Memo to: Robert E. Sanchez, U.S. Government Accountability Office

From: Robert H. Gilkeson, Registered Geologist

Date: January 24, 2013

Re: Follow Up to our meeting with the GAO in Albuquerque on January 7, 2013 about the GAO Questions to us for Review of the National Nuclear Security Administration's (NNSA) Interim Plutonium Strategy.

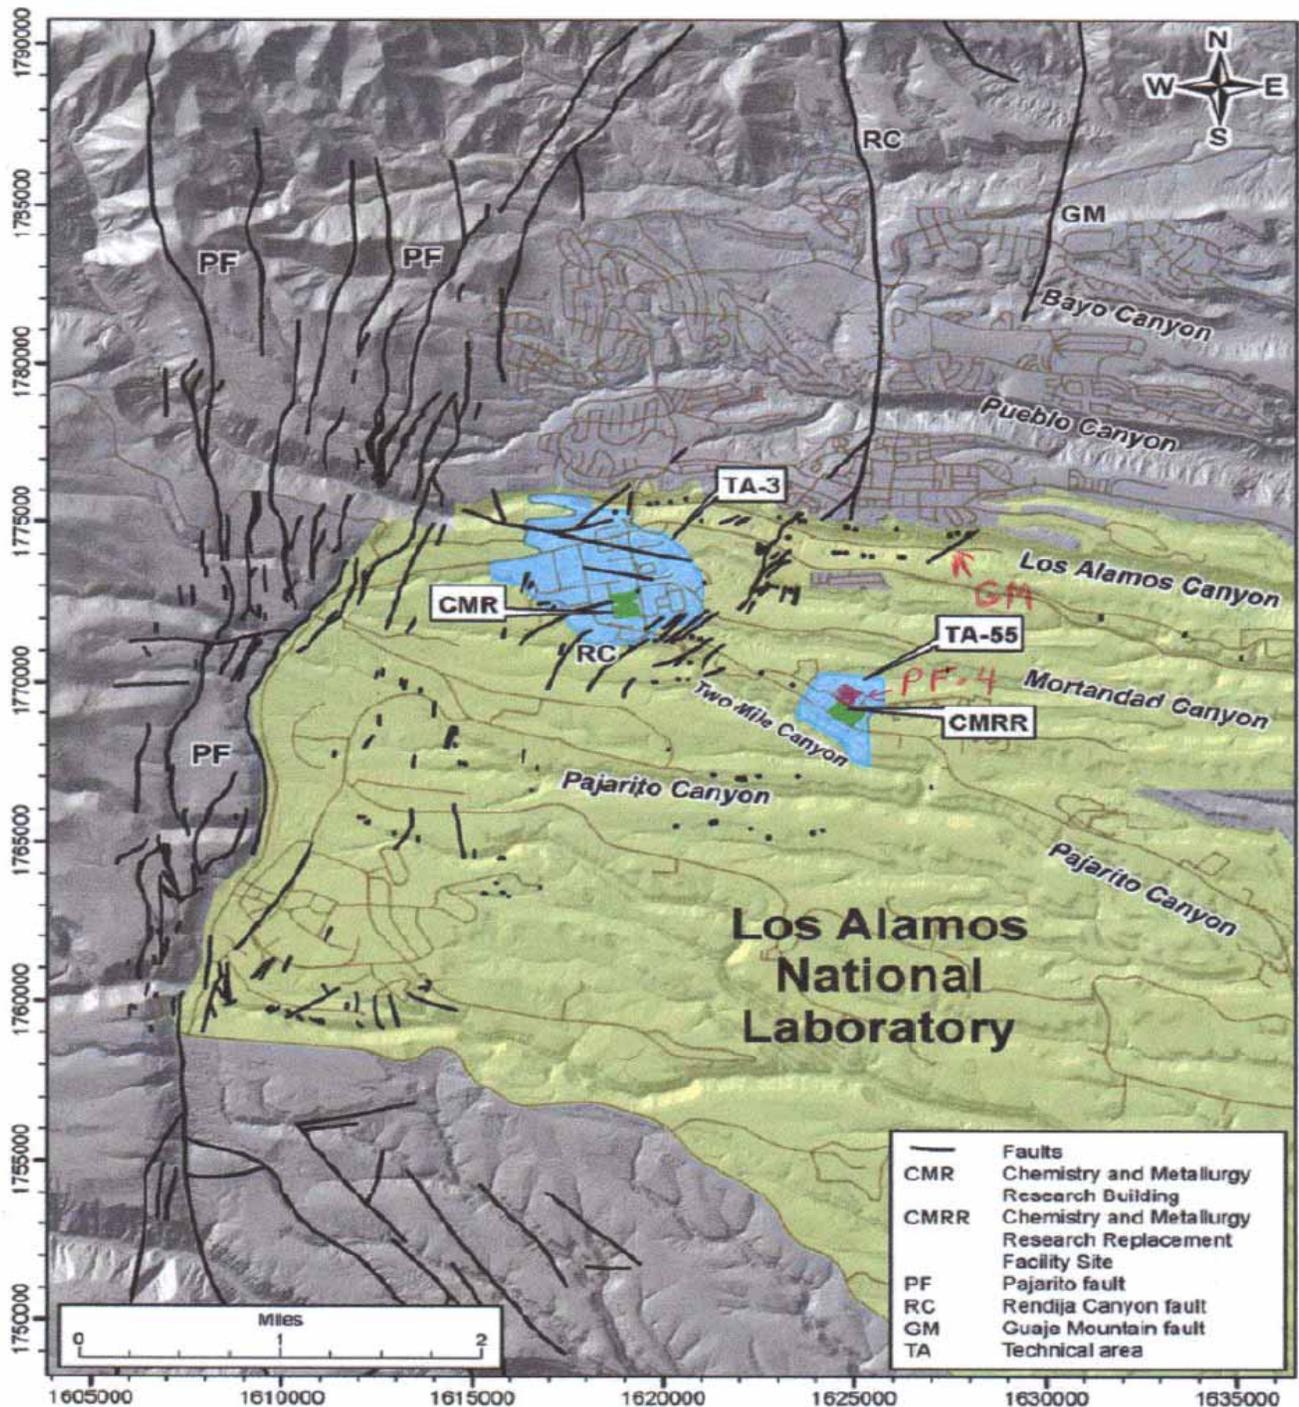
An additional very important reason is that the DBE of ~0.5g was based on only faults exposed at land surface at large distances away from the three nuclear facilities (see Figure 2) and did not include the two north-south trending concealed active faults that are located close to the PF-4, the RLUOB and the proposed CMRR-NF (see Figure 3). The two concealed faults greatly increase the ground motions above the DBE of ~0.5g.

However, the DNFSB letter of January 3, 2013 describes not “*minimal damage*” but instead, the structural collapse, spill and fire at the PF-4 with a lethal dose release of 900 rem plutonium in the air pathway for ground motions of 0.5g from an earthquake return period of 2,500 years. The ground motion values were from the LANL 2009 PSHA report for a single simultaneous earthquake based on mapping of only the faults that produced ruptures at land surface great distances away from the PF-4 (see Figure 2 compared to Figure 3 for the concealed active faults close to the PF-4).

The Senate Report 112-173 on page 282 statutorily imposed a cost ceiling of \$3.7 Billion for the construction of the CMRR-NF at LANL at the location close to the PF-4 displayed on Figure 1. The \$3.7 Billion cost is not technically defensible because it was based on earthquake ground motions of 0.5g for the faults mapped at land surface great distances away from the CMRR-NF on Figure 2. The actual cost will be much higher than \$3.7 Billion because of

Figure 3. The concealed active RC Fault located ~800 ft west of the PF-4 and the concealed active GM Fault located ~2,000 ft east of the PF-4.

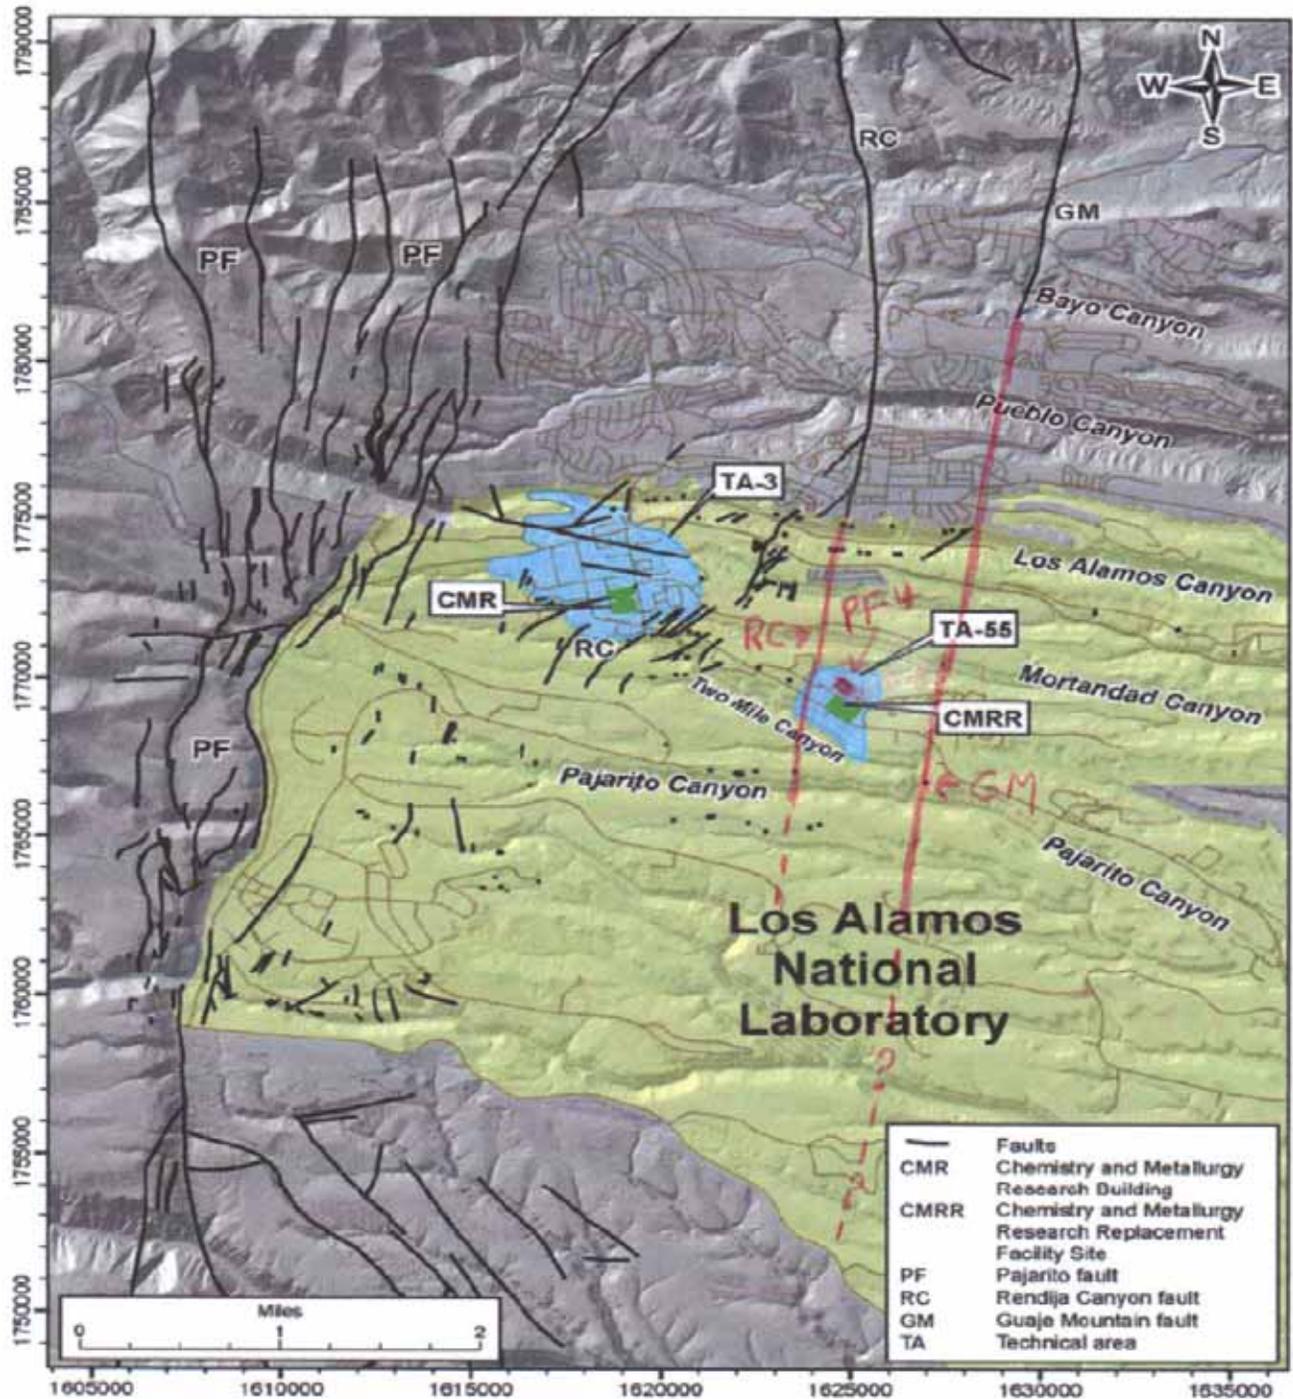
- (1) the close locations of the concealed active faults displayed on Figure 3 and
- (2) the requirement to design for the greater ground motions for a SDC-5 nuclear facility because of the very large inventory of plutonium.

Note: The concealed faults are displayed in red and dashed where inferred. The concealed faults were not included in the structural upgrades for the PF-4, for the construction of the RLUOB, or for the engineering design of the proposed CMRR-NF.

Figure 4. Seismic Hazard Curves For Peak Horizontal Ground Motions From Simultaneous Ruptures From A Single Earthquake At LANL TA-55.
Source: Figure 7 in the LANL 2009 PSHA Report.

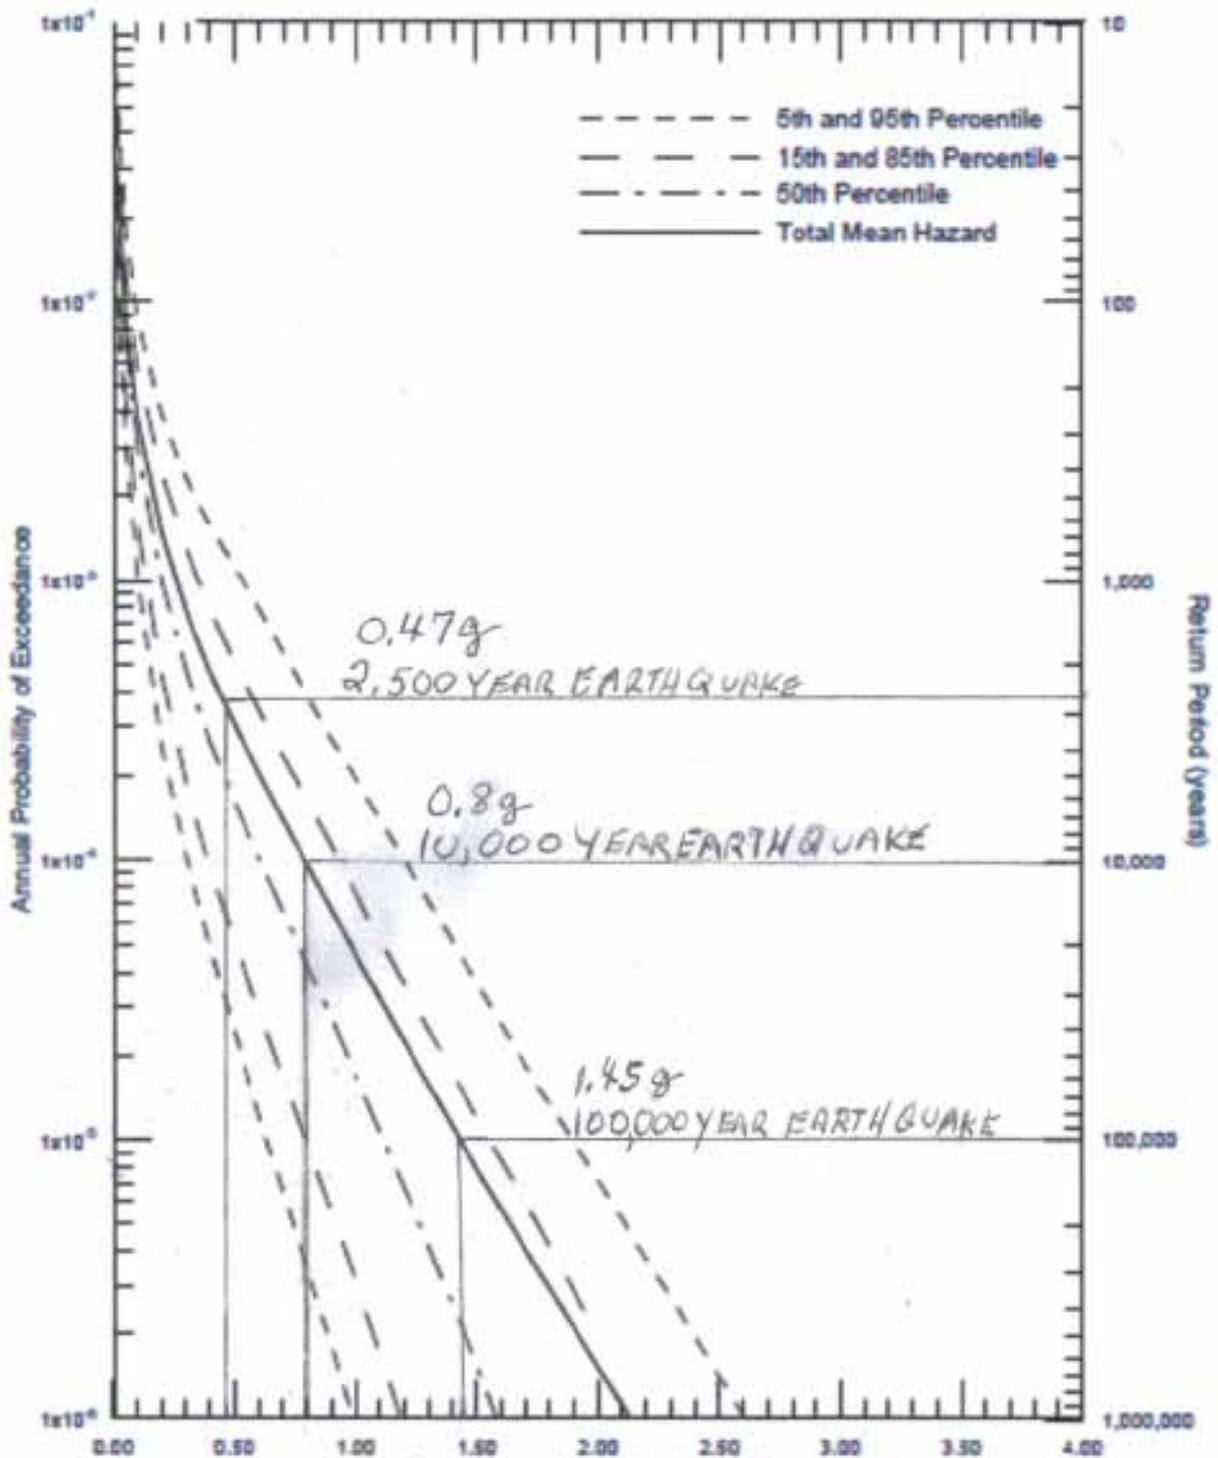
Figure 4 is a graph from the LANL 2009 PSHA that illustrates the ground motions from the single simultaneous earthquake as a function of earthquake recurrence period. The peak horizontal ground motions are 0.47g, 0.8g, and 1.45g for earthquake recurrence periods of 2,500, 10,000 and 100,000 years, respectively. The industry standards require the structural upgrades for the PF-4 to provide minimal damage from ground motions of 1.45g.

Nevertheless, the industry standards provide a concession for structural upgrades for the PF-4 to be based on ground motions of 0.8g; a value much higher than the 0.5g value that is currently used. But given the plutonium inventory stored at PF-4, and the increased inventory required for manufacture of up to 90 triggers per year, we believe that the 100,000 year earthquake recurrence should be used with ground motions of 1.45g.
